Project	IEEE 802.16 Broadband Wireless Access Working Group < http://ieee802.org/16 >	
Title	Uncoordinated Coexistence Protocol (UCP)	
Date Submitted	2006-09-17	
Source(s)	Paul Piggin NextWave Broadband Inc. 12670 High Bluff Drive San Diego CA 92130 USA	Voice: 1 858 480 3100 Fax: 1 858 480 3105 ppiggin @ nextwave.com
	Lei Wang NextWave Broadband Inc. 12670 High Bluff Drive San Diego CA 92130 USA	Voice: 1 858 480 3100 Fax: 1 858 480 3105 lwang @ nextwave.com
	Ken Stanwood Cygnus Communications Inc. 12670 High Bluff Drive San Diego CA 92130 USA	Voice: 1 858 480 3100 Fax: 1 858 480 3105 kstanwood @ cygnuscom.com
Re:	Working Group Review of Working Document IEEE 802.16h-06/015r1	
Abstract	This document contains the definition of an Uncoordinated Coexistence Protocol in order to meet the spirit of the FCC and Industry Canada mandates in certain non-exclusively assigned/licensed bands.	
Purpose	To provide a mechanism whereby 802.16 transmitters can be expected to provide reasonable opportunities for other transmitters to operate.

Uncoordinated Coexistence Protocol (UCP)

Paul Piggin, Lei Wang
NextWave Broadband Inc.
Ken Stanwood
Cygnus Communications, Inc.

Figure x: EQPs Map Relevance = $n+1$

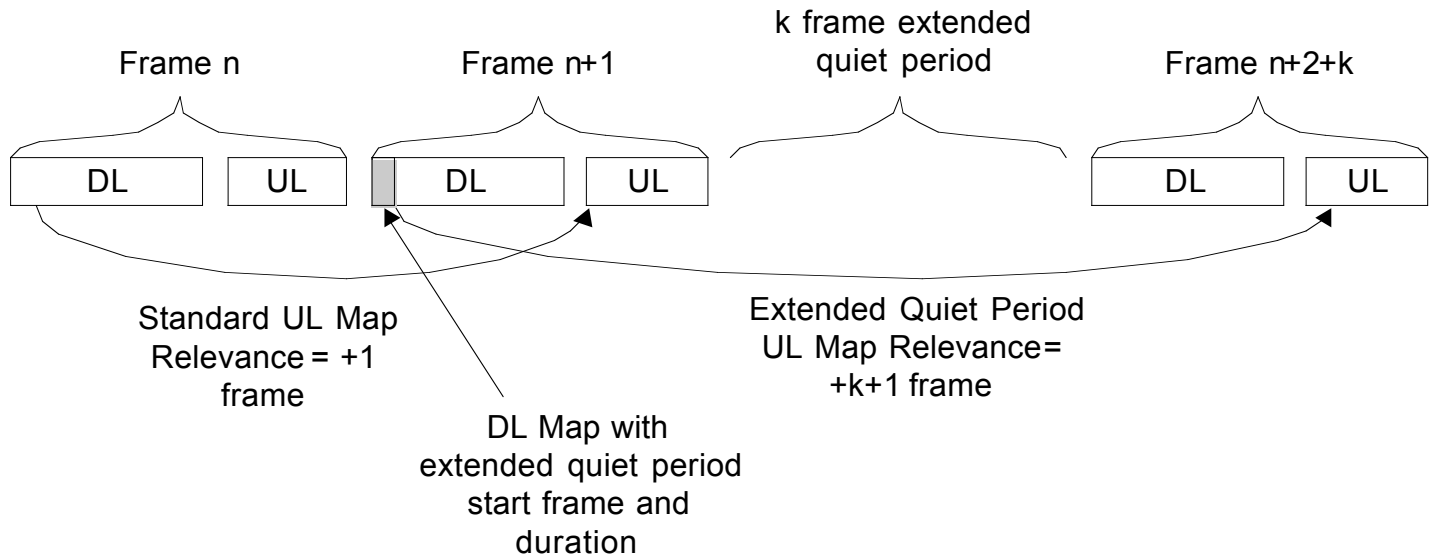
The duration, in frames, of the EQP is signaled in the DL-MAP using the EQP_IE defined in 8.4.5.3.29. The EQP always starts in the frame following the DL-MAP containing the EQP_IE. In addition to the duration of the EQP, the report_requested field indicates whether measurement and reporting on the channel should be performed during the EQP. If the report_requested bit is set to 0, no automatic measurement and reporting is requested. When it is set to '1', then all SS will make measurements as if commanded to create a *Basic Report* in REP-REQ

(11.11). They will transmit a corresponding REP-RSP message if a measurement detected activity above the threshold for the frequency band of operation. The need for bandwidth to transmit a report may be signaled through any of the standard methods for signaling a need for UL bandwidth. When the UL-MAP relevance is the next frame as it is for WirelessMAN-OFDMA based systems, the UL-MAP transmitted in the last DL subframe before an EQP describes the allocations for the first UL subframe after the EQP. This is shown in Figure x. The periodicity of EQP is described in the next sub clause. This discontinuity of the UL-MAP relevance does not exist in the case where the UL-MAP describes the allocations for the current UL subframe as is possible in some WirelessMAN modes. In this case the DL and UL subframes can be more closely associated with each other. This will be important for a listen-before-talk capability. The case of EQPs with UL-MAP relevance for the current frame is shown in Figure x2.

Figure x3: Adaptive EQP (with example parameter numbers)

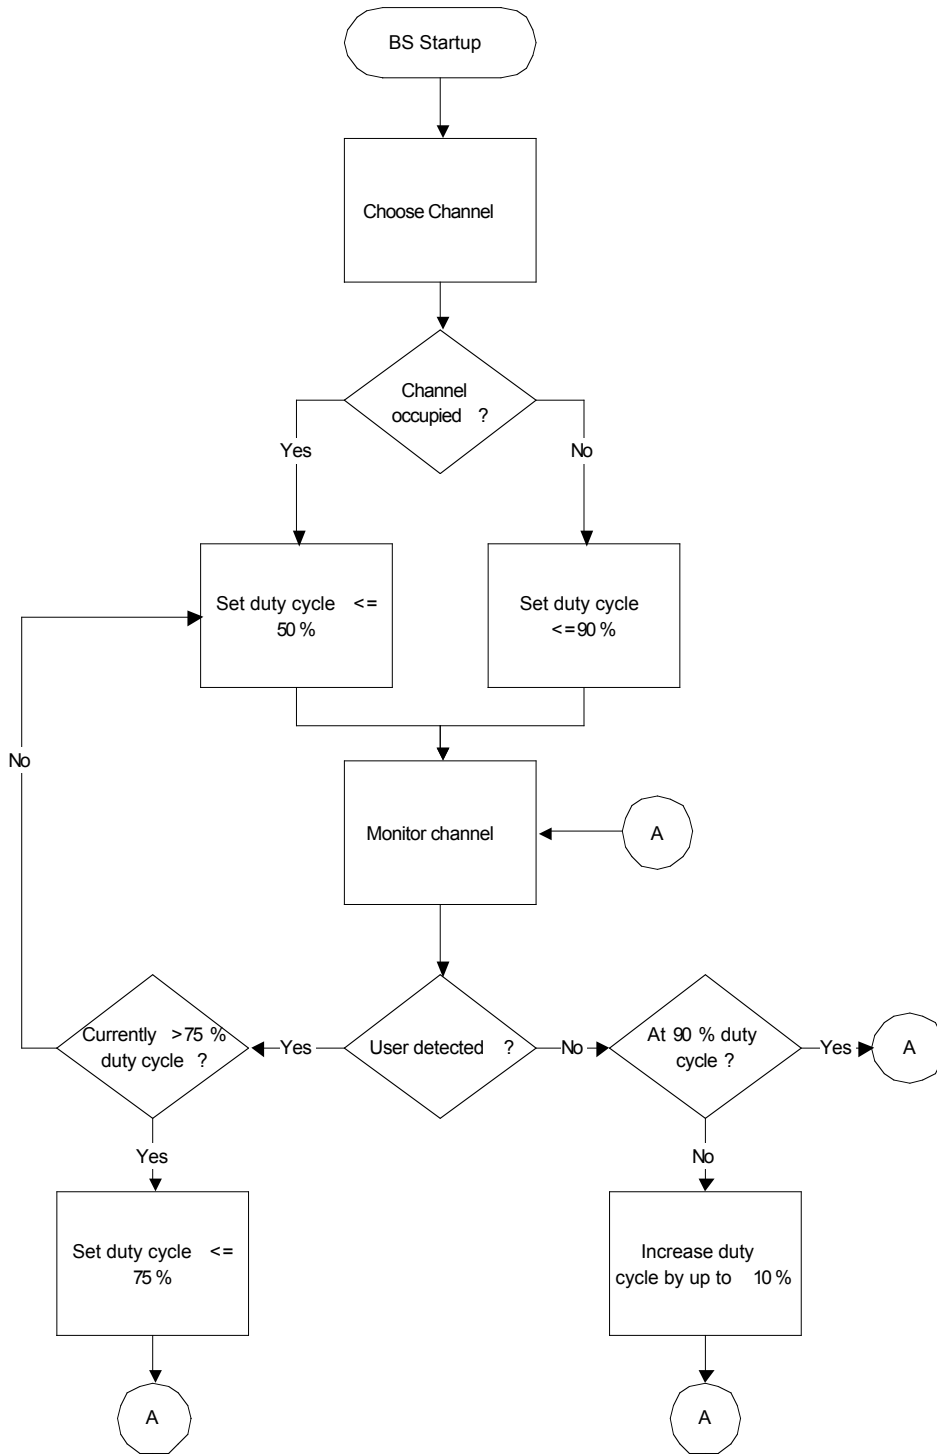
There may be bands where there is a possibility of other users, but the probability is low. In these cases, it is important to not waste bandwidth catering to non-existent user of the band. When EQPs are used in a non-exclusively assigned or licensed band, a BS initially offering service shall perform an initial (DFS/DCS) scan and pick the *best* channel. Based on this choice, if the channel is thought to be free of other users, the BS shall set the initial duty cycle to no more than *max_duty_cycle*. If another user was detected, the BS shall initially operate a duty cycle of no more than *share_duty_cycle*. Duty cycles are measured over a 1 second period. This duty cycle can be achieved a number of ways. For instance a 50% duty cycle can be achieved: with the use of every other frame, n frames on and n frames off, or operate in $n/2$ of n frames, etc. The method of achieving the duty cycle shall be left for vendor differentiation which increases the likelihood of randomization of the algorithm of two different BS from two different operators which in turn increases the likelihood of their ability to eventually detect each other or an SS associated with the other BS.

If after a prolonged period which is band specific in duration, the BS and its associated SSs have not detected other users in the band through measurement and reporting during EQPs coupled with measurement and reporting as performed for DFS/DCS then the BS may increase its duty cycle by *duty_cycle_step*. The duty cycle shall not increase above *max_duty_cycle* as measured over a 1 second period. The BS shall continue to measure and shall continue to instruct SSs to measure and report using the EQPs and the DFS/DCS mechanisms. If a SSU is detected, the band specific regulations shall be followed. If another user that is not a SSU is detected the BS shall reduce its duty cycle to at most *intermediate_duty_cycle* within 10 frames of the BS becoming aware of the detection. If the detected user persists, the BS shall reduce the duty cycle to at most *share_duty_cycle*. The flow is shown in Figure x3 using example parameters: *share_duty_cycle* = 50%, *intermediate_duty_cycle* = 75%, *max_duty_cycle* = 90%, and *duty_cycle_step* = 10%.

Figure x4: Listen-Before Talk

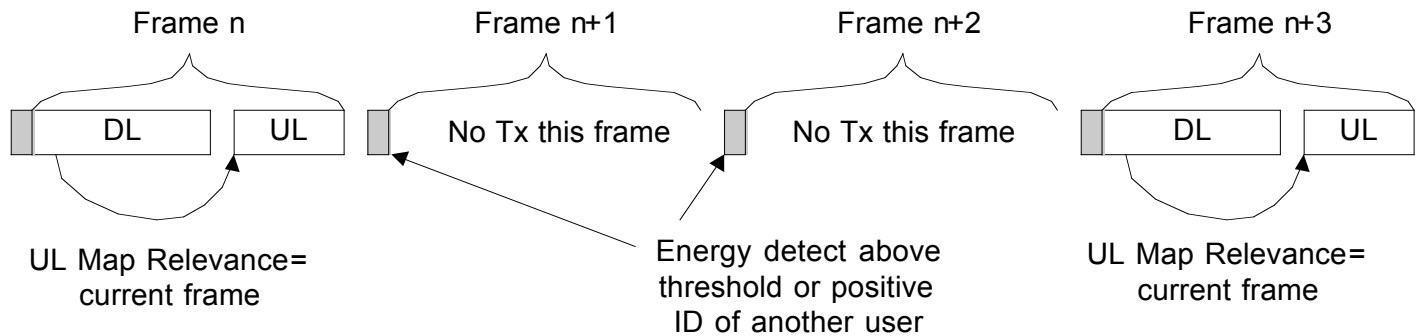
When attempting to coexist with certain non-802.16 users of non-exclusively assigned or licensed bands, EQPs may not be sufficient. In these cases, a listen-before-talk protocol must be used. In such bands, the BS shall operate with a UL-MAP relevance of the current frame. This allows the DL and UL subframes to be logically viewed as a single “packet” of constant duration equal to the frame duration. The BS shall allocate the UL

subframe such that a time period is reserved between the end of UL allocations and the start of the frame preamble for the next DL subframe as shown in Figure x4. This time period shall be used to sense other non-802.16 systems and shall have at least the durations specified in Table x2. Use of listen-before-talk shall not eliminate any requirements for other measurement and reporting that may be required for operation in a particular mode or band. Use of listen-before-talk shall not eliminate any requirement for use of EQPs.
